## Report pursuant to s42A Resource Management Act 1991

<b>In the matter of:</b>	A Notice of Requirement to construct and operate a new intermodal rail and freight hub on land between Palmerston North and Bunnythorpe
<b>And:</b>	A hearing by Palmerston North City Council pursuant to s100A
<b>Requiring Authority:</b>	KiwiRail Holdings Ltd
<b>Hearing date:</b>	Commencing 9 August, 2021

Section 42A technical evidence summary statement for hearing: Transport

Figure A6 FLB or HAB active control

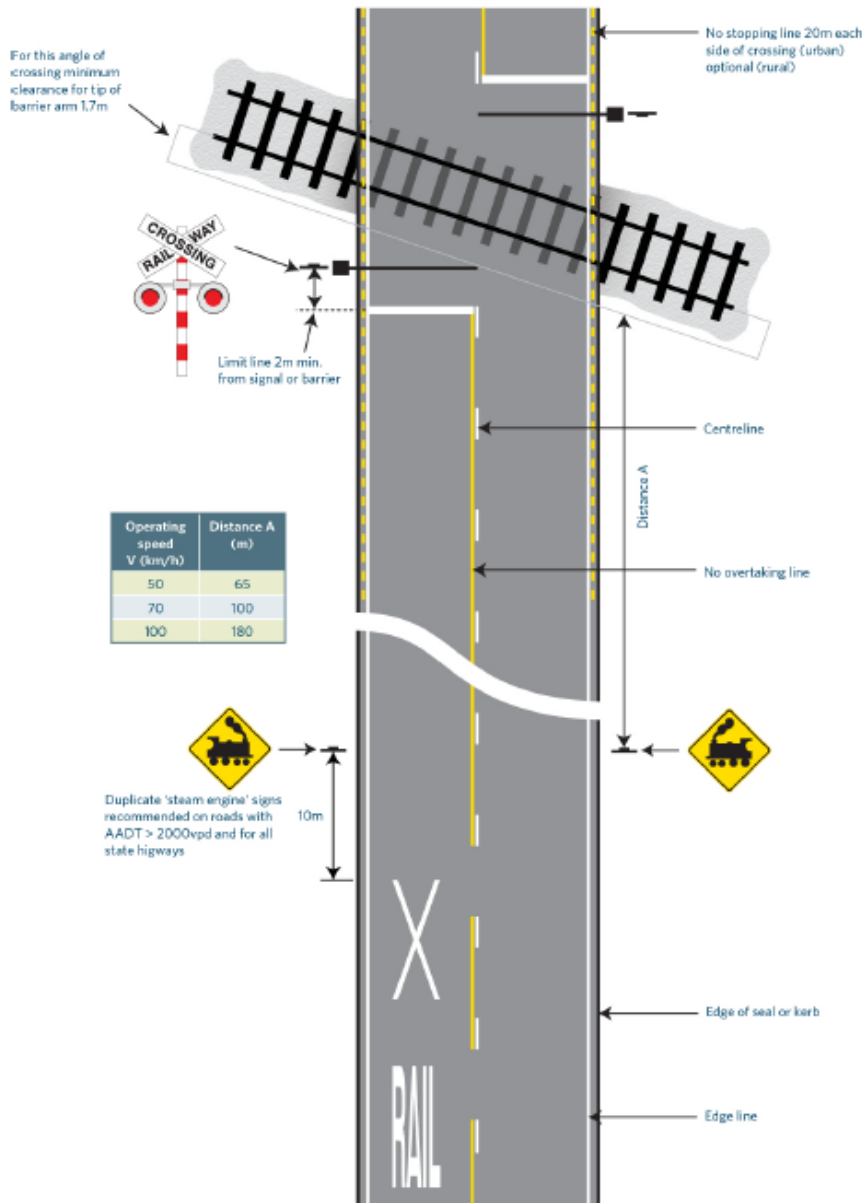
13. As a result of both Michael Skelton's and Mark Georgeson's presentations, there was a discussion around the interaction between the internal rail level crossing and the external road network. The discussion focused on queuing space for vehicles turning into the site, other matters include forward sight lines to the crossing and to queues formed at the crossing. From the extract below (sourced from the NZ Transport Agency's Traffic Control Devices Manual Part 9 Level Crossings) it appears unlikely that there will be enough distance between the Richardsons Line/ Roberts Line roundabout and the internal rail level crossing to accommodate the necessary advance warning signage and markings. This highlights the need for road safety audits to be undertaken of the access points to the Freight Hub site with particular consideration of the interaction with the internal level crossings.

14. The detailed design of the intersection will also need to include measures to prevent traffic queuing to enter the site from blocking back through the intersection. Some queuing provision is shown for traffic turning in left or right from Roberts Line but a similar provision for vehicles entering from Richardsons Line is more difficult to include.
